SIB 12 12 20

RECALL 20V-761: CHECK 48 V CABLE CONNECTIONS TO THE STARTER GENERATOR (SGR)

This Service Information Bulletin (Revision 2) replaces SI B12 12 20 **dated December 2020**.

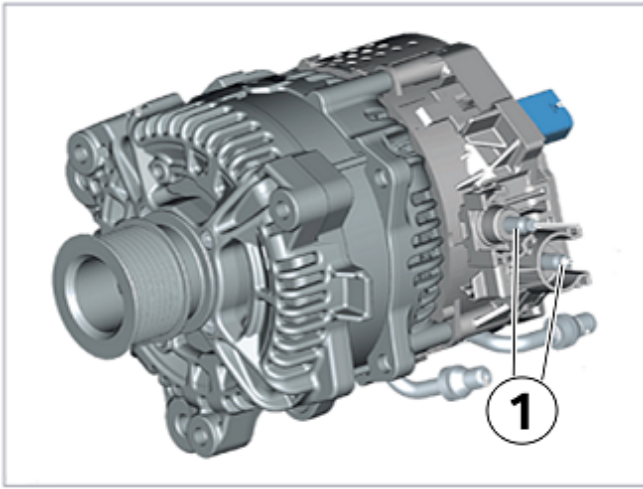
Check the positive (1) and negative (2) cables for play at the mounting lugs on the SGR.

If there is play in the connection to the SGR –

- Deactivate the 48 V electrical system (Repair instruction REP-TAT-P-6124-18-B47_48V)
- Remove and discard the flange nut on the B+ or B- cable.
- Install a new flange nut so that it's carefully started by hand to avoid cross-threading
- Torque to 19 Nm
